SERVICE BULLETIN

Series PS-800 & PS-850 LWCO's

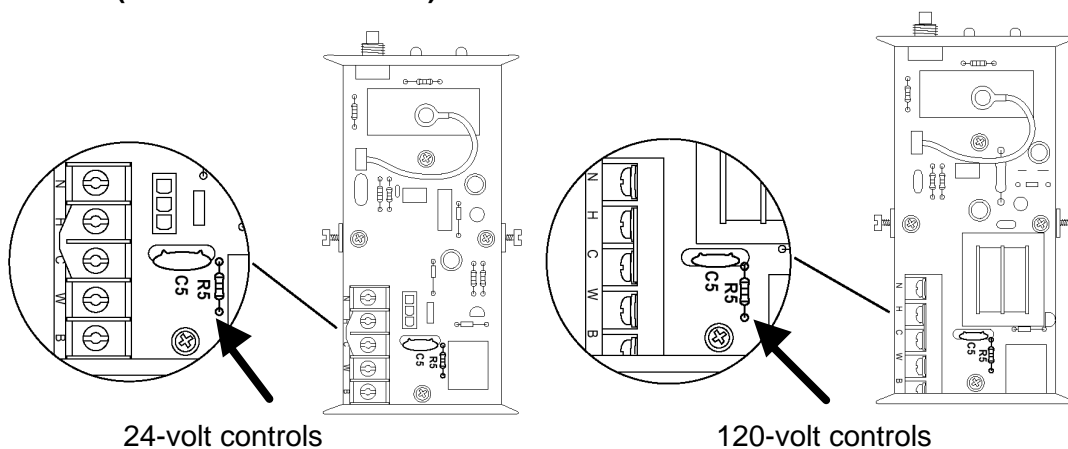
However, if field repair is more desirable, removal of a component on the circuit board is required. The affected circuit consists of two components, resistor (R5) and capacitor (C5). The locations of these components are directly above the terminal block for both 24-volt and 120-volt controls (see diagrams below). We recommend the removal of resistor (R5) by carefully cutting the component leads. To remove (R5), turn off power to the unit and clip the wire leads connecting the component to the circuit board. **(Continued on reverse).**

To remedy this situation, McDonnell & Miller recommends either field repair or replacement of the Series PS-800 and PS-850 controls under warranty. If you choose to replace the control, please follow McDonnell & Miller's normal warranty procedure.

The affected circuit has been removed from all units manufactured beginning **December 2001 (date code 01M)**. Units with this or later date codes are not affected by this service bulletin.
